**CITY OF BEAUFORT
ZONING BOARD OF APPEALS
Staff Report and Recommendations
Meeting of 26 September 2016**

Case Number: ZB16-13
Property Address: 707 Church Street
Applicant: Labi Kryeziu and Tom Michaels, Architect
Type of Request: Lot area variances
Zoning: General Residential

**CITY OF BEAUFORT
ZONING BOARD OF APPEALS
Staff Report and Recommendations
Meeting of 25 July 2016**

SEPTEMBER HRB SUBMITTAL

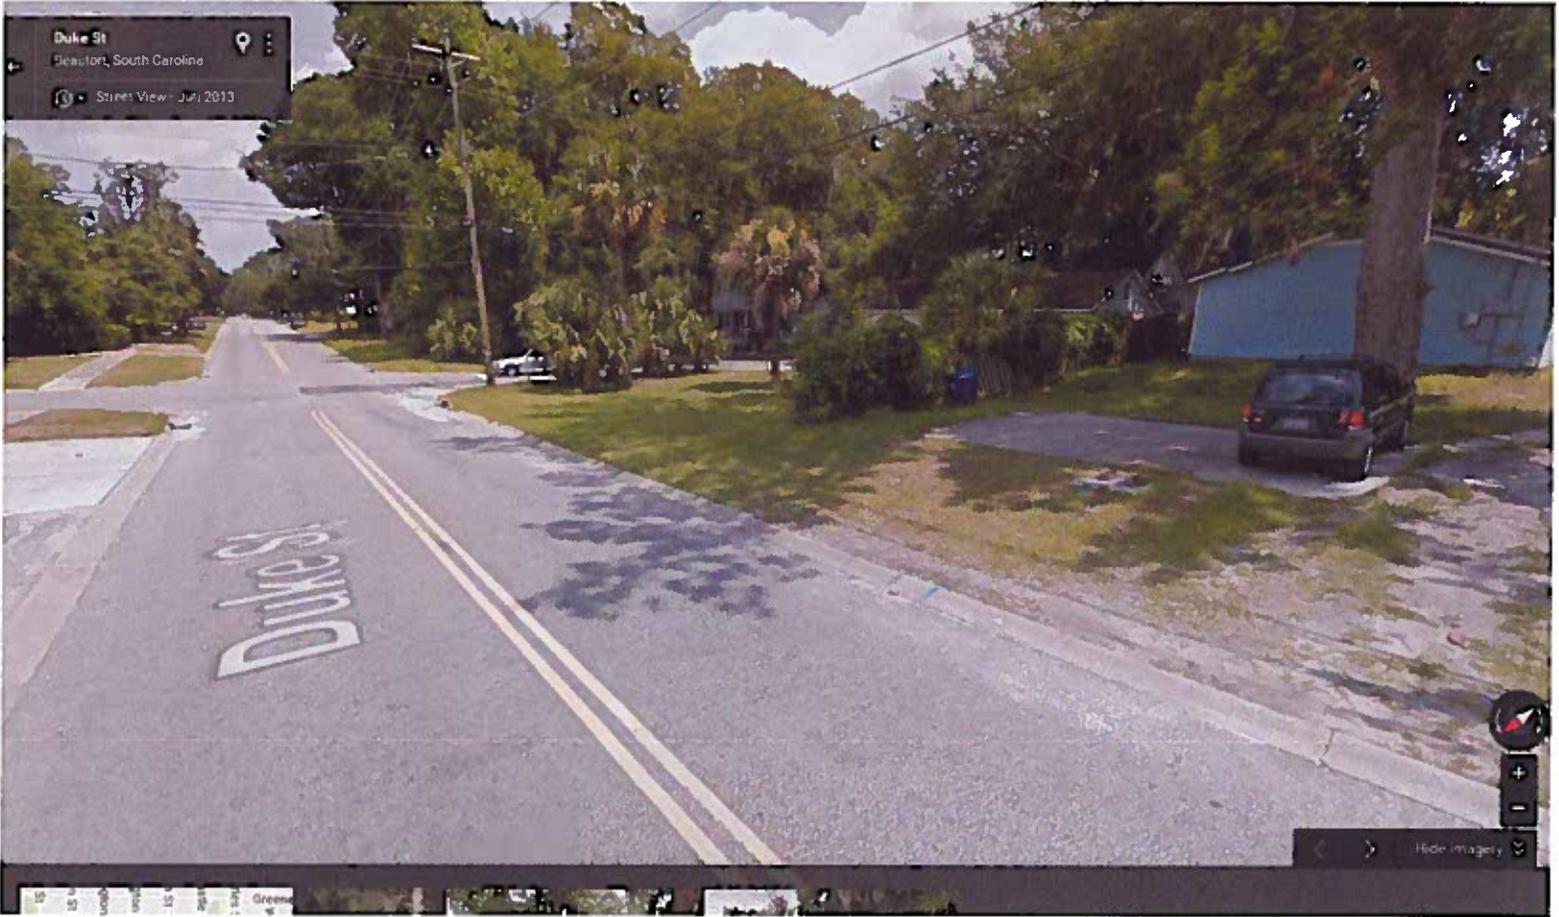
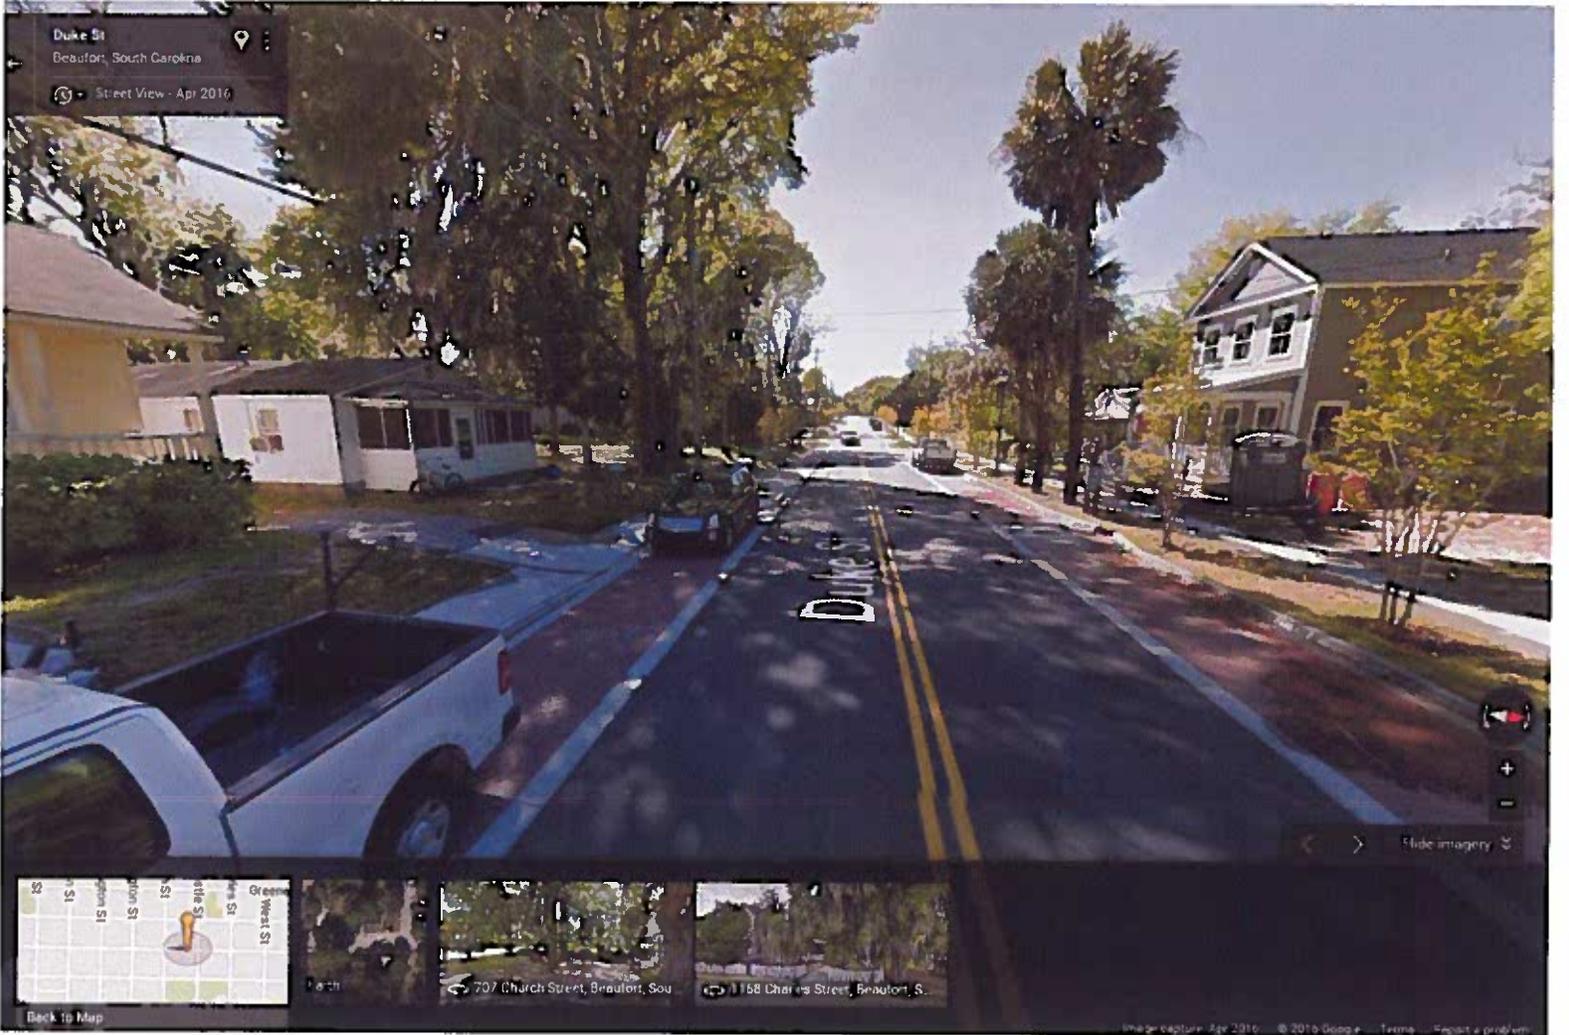
- What are the plans for the existing structure? It is not contributing but is fairly old. Staff would like a plan to restore/renovate this structure to accompany any final HRB approval for new construction on the northern-most lot.

- If the variance for the subdivision is approved, staff supports the proposed building, or one of a similar size, mass and scale, for this property.
- The proposed structure is appropriate for this district. Staff recommends divisions of the windows such as 2/2 or 4/4

- Drawing 3/A201 should be labeled “South Elevation”
- The bedrooms show single windows in plan but double in elevation. The plan should be updated to coordinate with the elevation.

1. Staff recommends the HRB give a favorable recommendation to the ZBOA with the following conditions:
 - The house proposed, or one similar in size, mass and scale and no greater than 1.5 stories, be approved by the HRB.
 - The rest of the zoning requirements, except for the encroachment of the stoop into the interior side setback, should be met without any further adjustments.
 - In addition, a plan and timeframe to restore/renovate the existing structure should be provided prior to final approval of a structure for this parcel.
2. Staff recommends the HRB give conceptual approval to the house submitted, with final approval contingent on variance approval from the ZBOA, and modifications of the window divisions.

ASBUILT SURVEY AND PROPOSED SUBDIVISION PREPARED FOR
LABI KRYEZIU
 BEING THE NORTHWEST CORNER OF BLOCK 87 IN THE CITY OF BEAUFORT AS RECORDED
 IN DEED BOOK 3435, PAGE 2788 BEAUFORT COUNTY R.M.C. OFFICE
 LOCATED IN THE CITY BEAUFORT COUNTY SOUTH CAROLINA
 TAX MAP R120 004 000 0498 0000

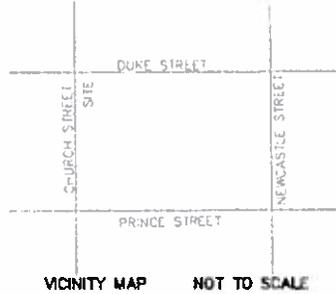
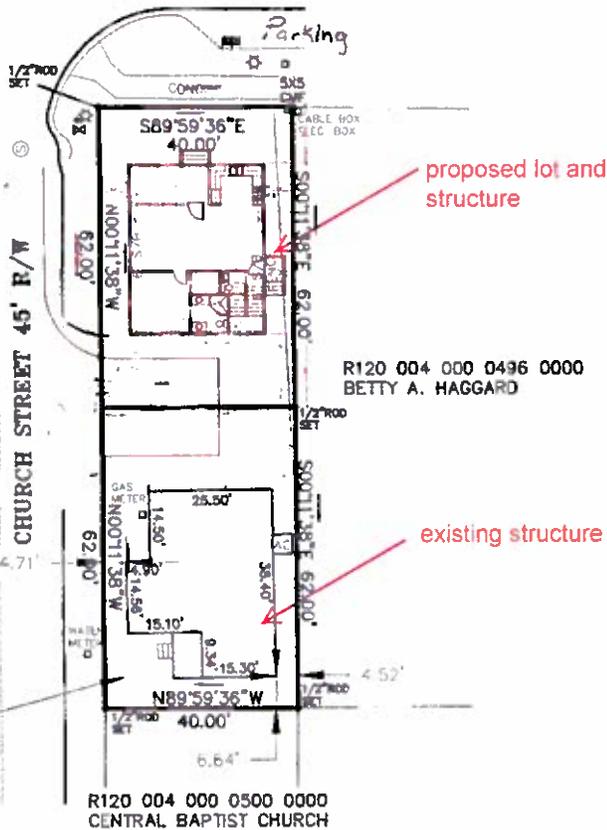
The plat should be revised to label the lots as Lot A and Lot B or Lot 1 and Lot 2.
